**Addendum #1 - IFB 26-014 Myers WTP Electrical Query Project**

# MOBILE AREA WATER AND SEWER SYSTEM MYERS WATER TREATMENT FACILITY ELECTRICAL QUERY PROJECT

ISAIAH ENGINEERING INC. PROJECT NO. IEMAWSS-0106

**NEW VFD ROOM PLAN (LOCATED BELOW EXISTING MCC ROOM)**  
SCALE: 3/4" = 1' - 0"

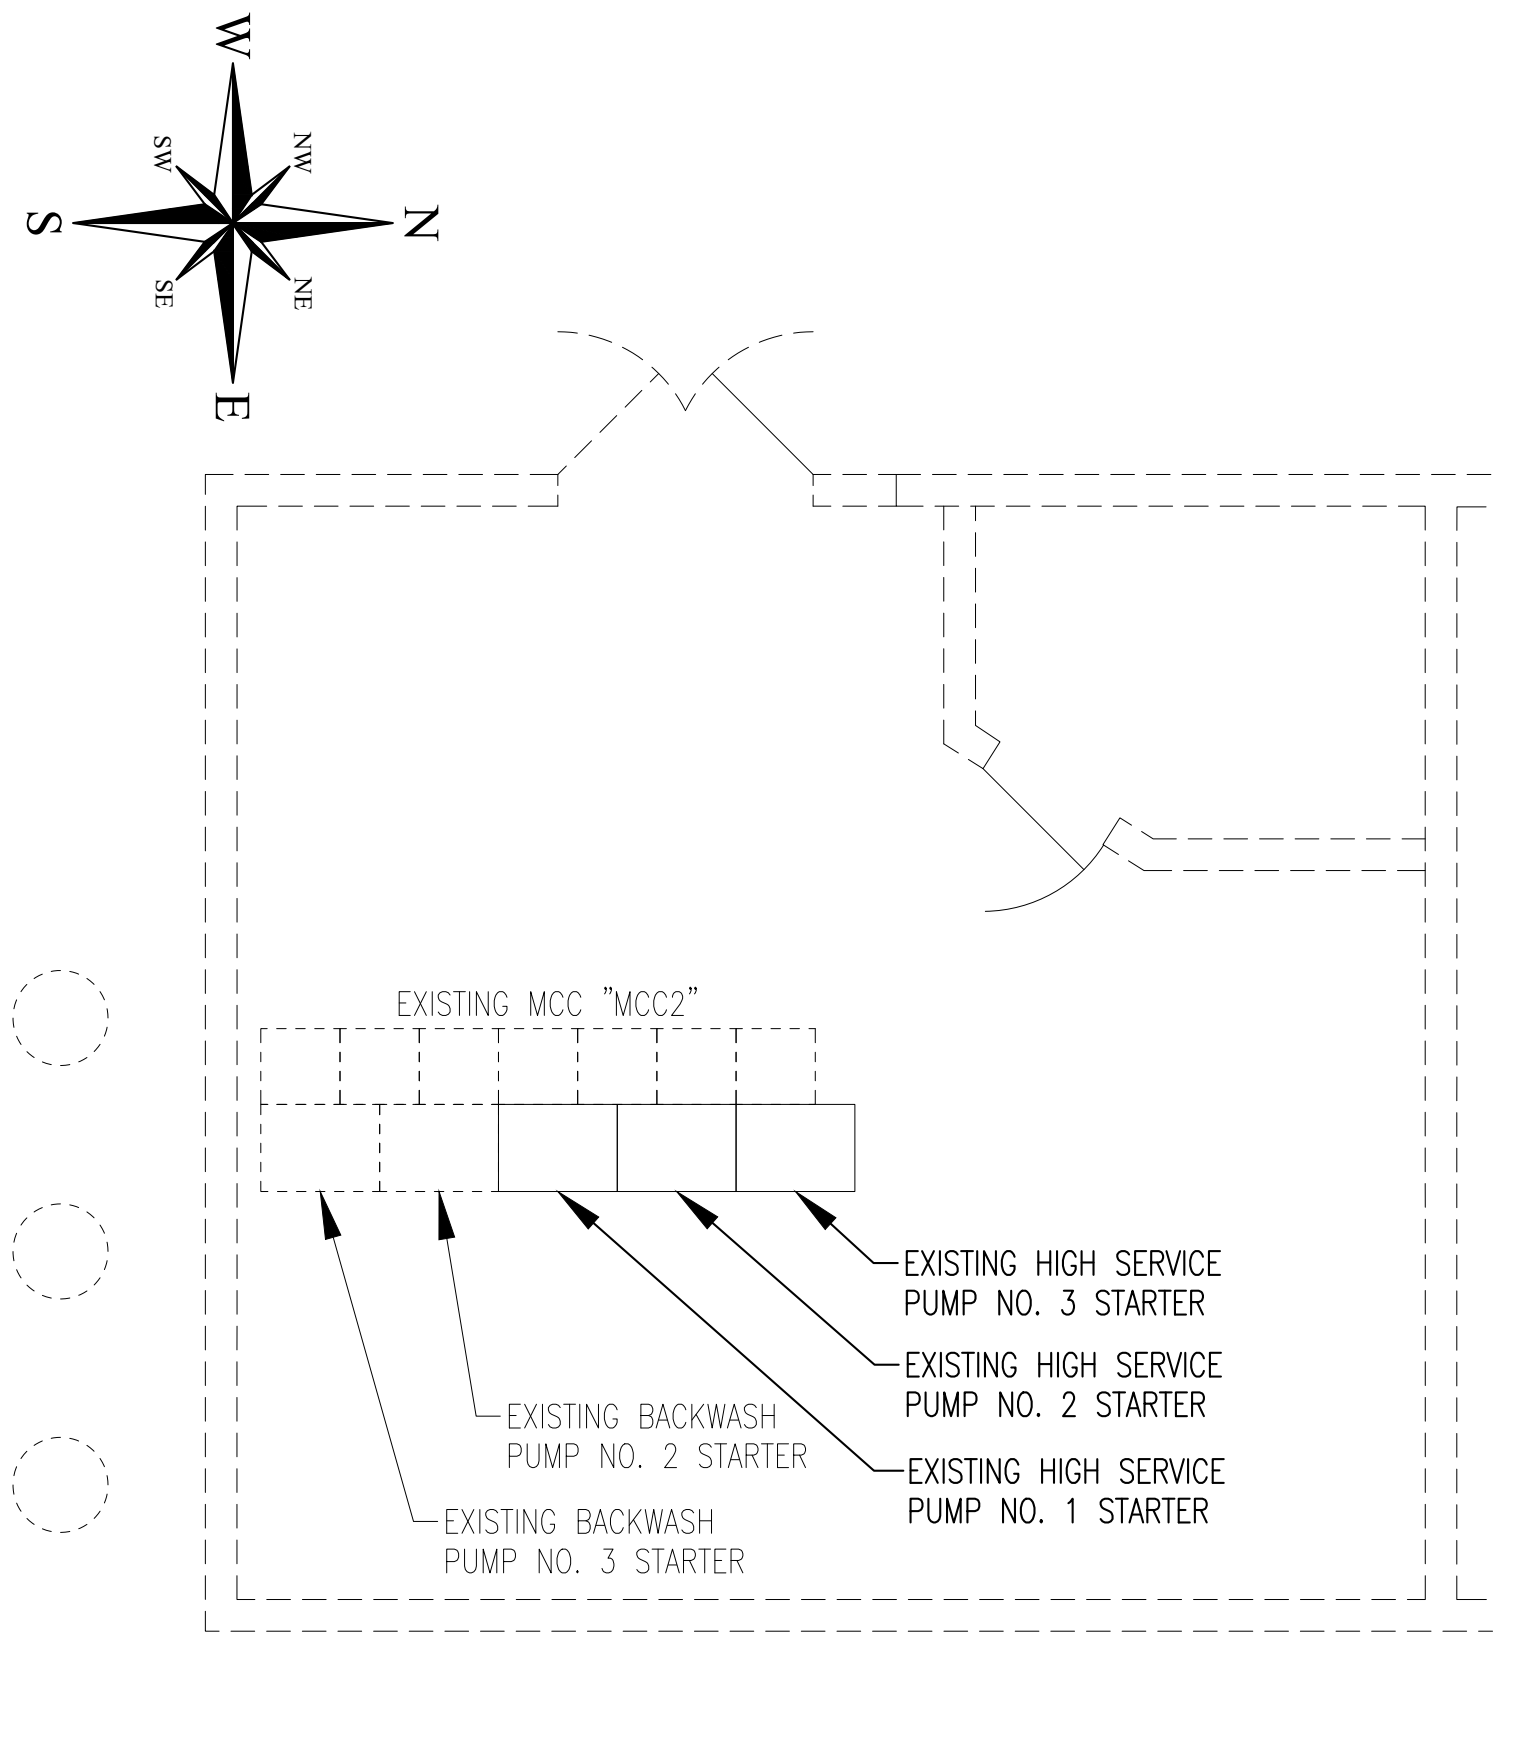
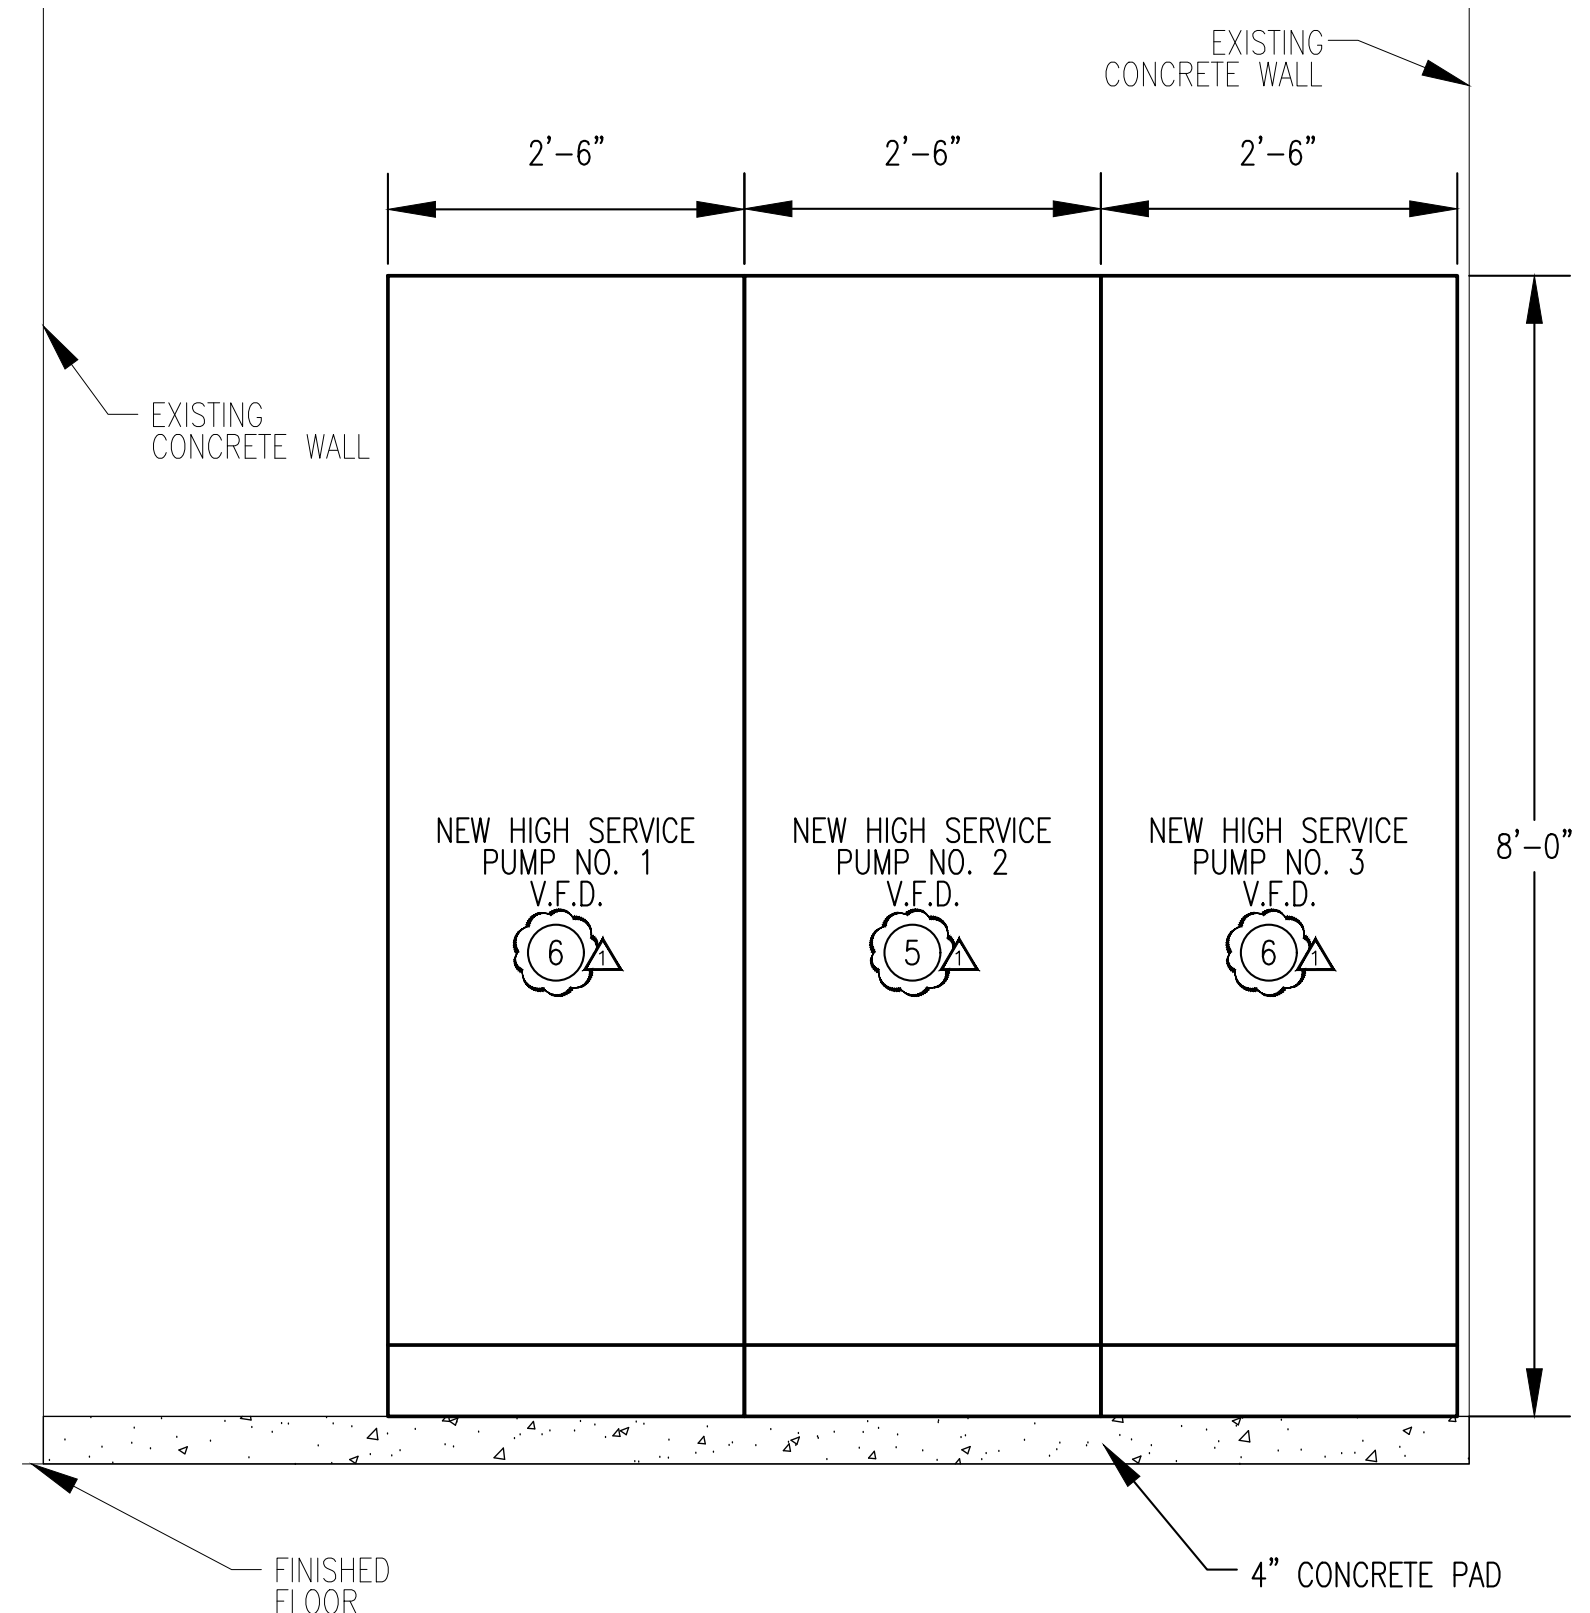
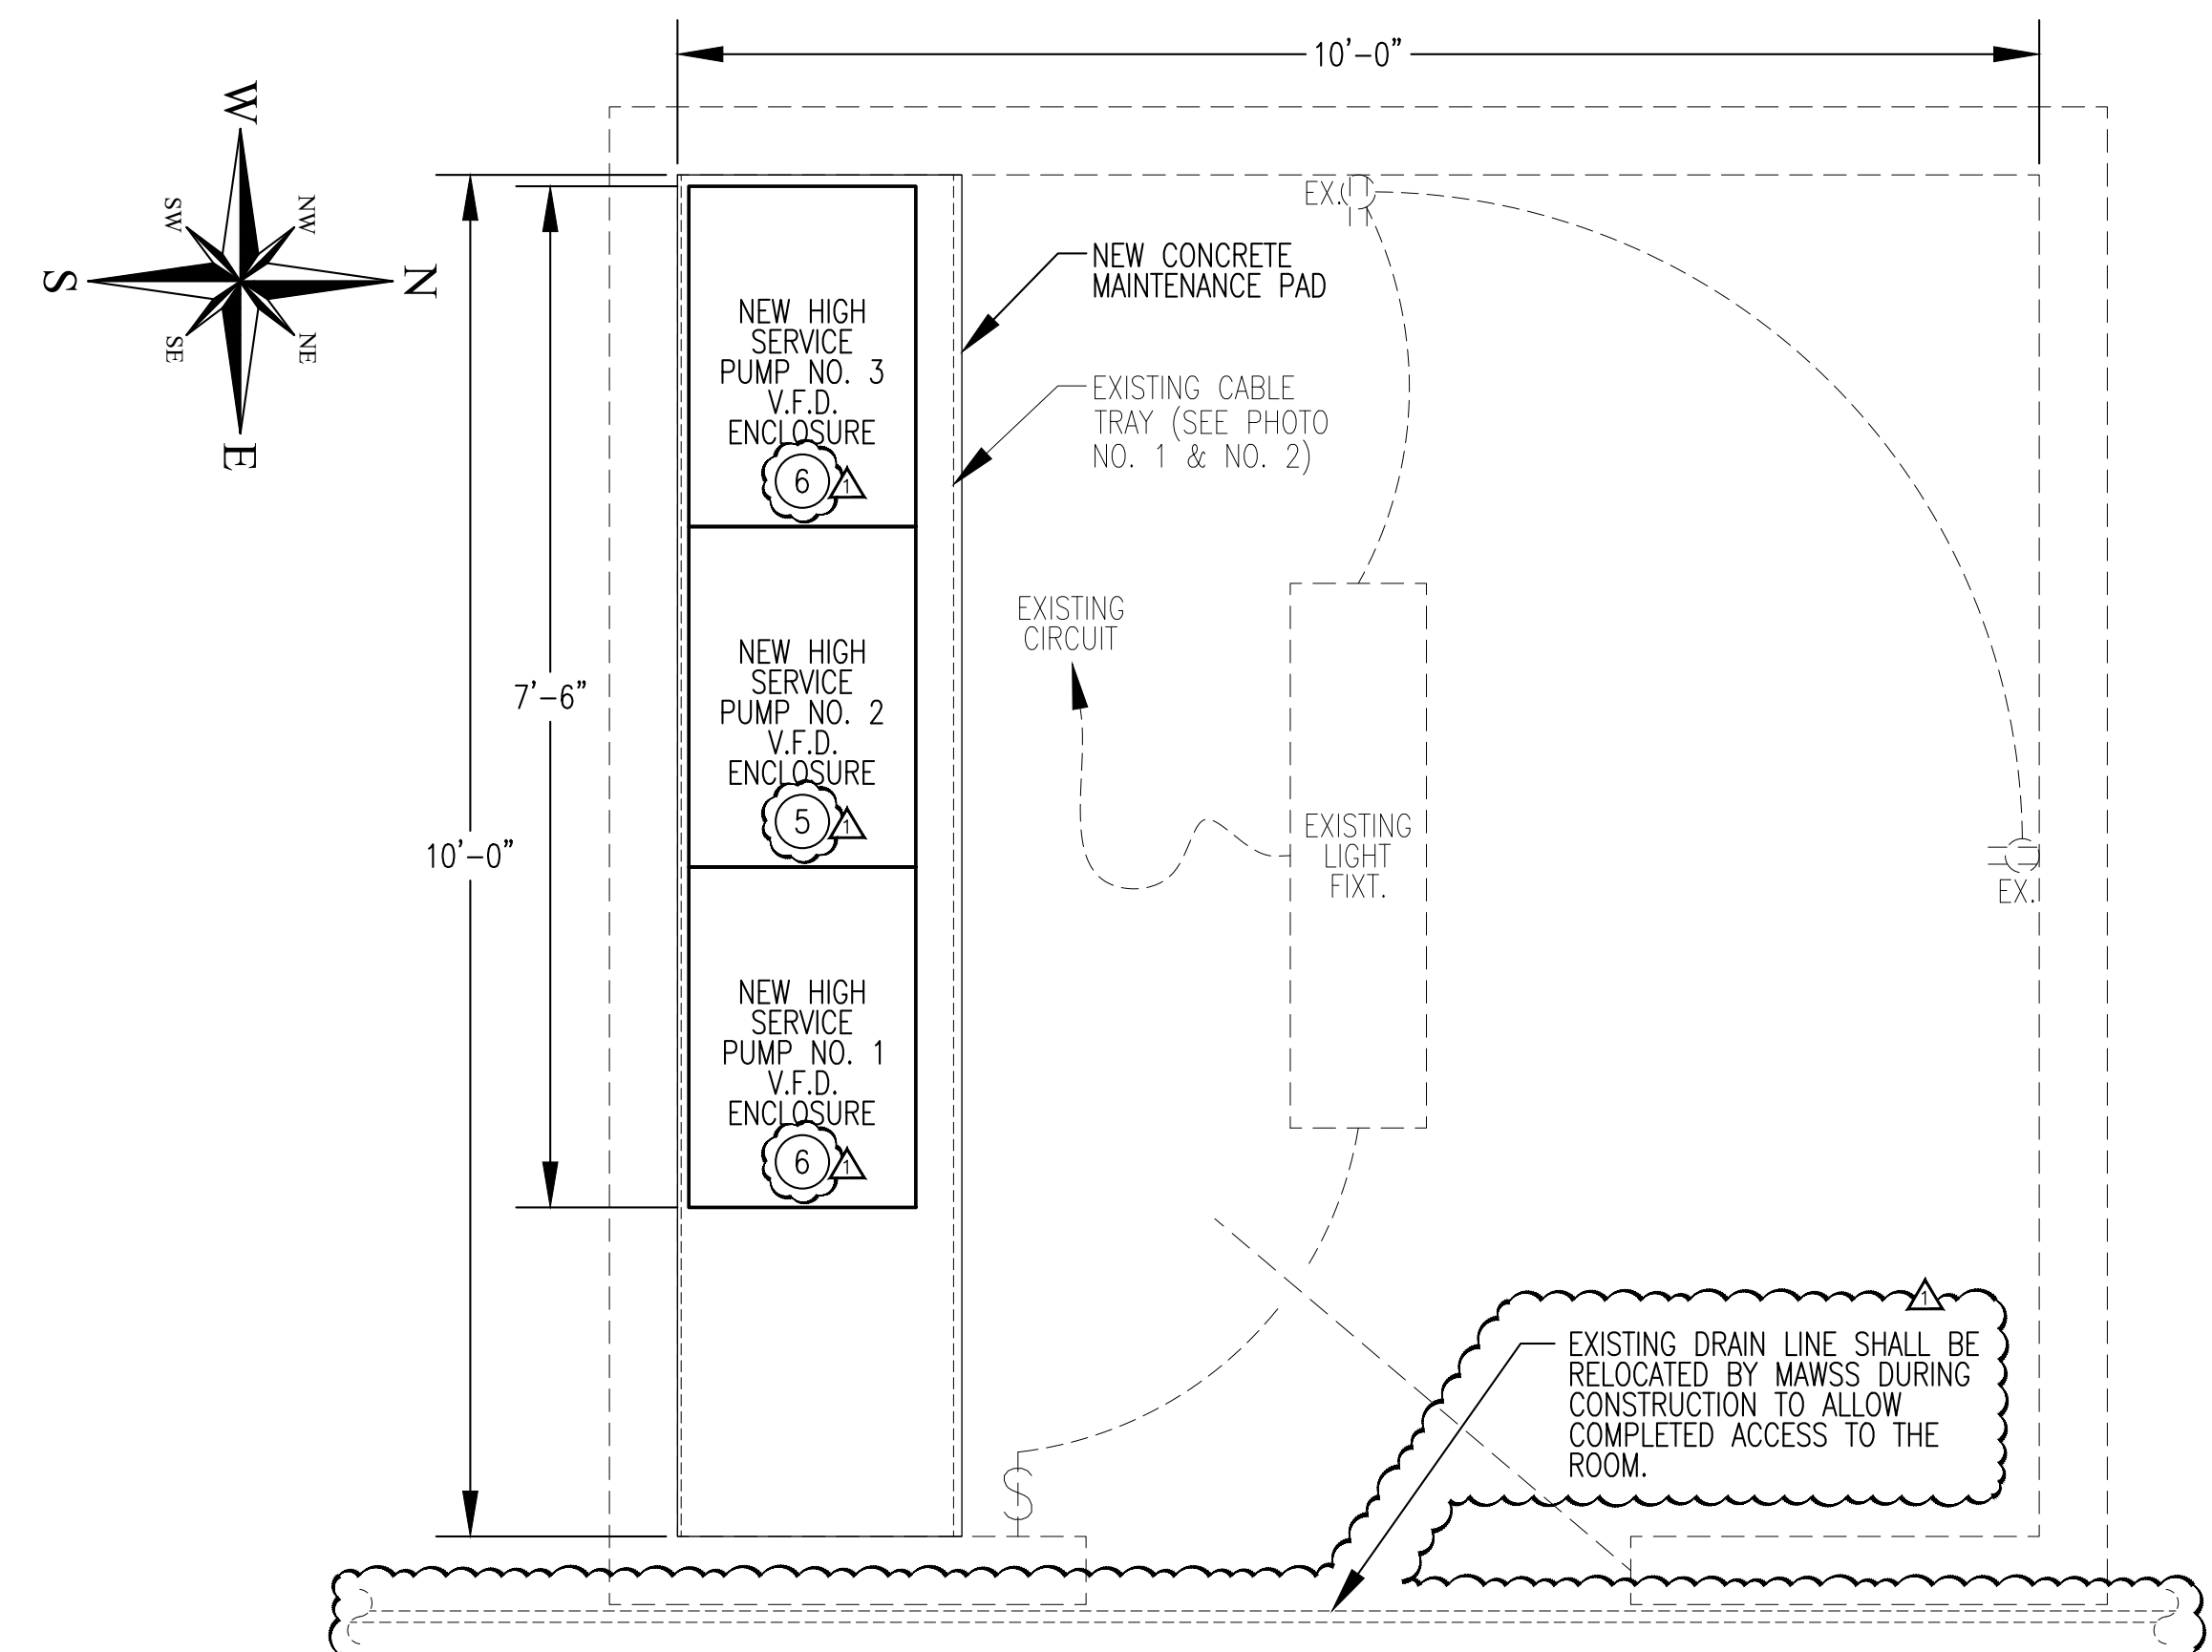
4. The original IFB drawings do not distinguish between the base bid and alternates. The drive for pump #2 is the base bid item. The drives for pumps 1 and 3 are additive alternates. The IFB document drawings are updated to indicate the change.

- 5 THE CONTRACTOR SHALL PROVIDE THE LABOR AND MATERIALS TO INSTALL THIS VFD ENCLOSURE IN THE BASE BID.
- 6 THE CONTRACTOR SHALL PROVIDE THE LABOR AND MATERIALS TO INSTALL THIS VFD IN THE ALTERNATE BID ITEMS.
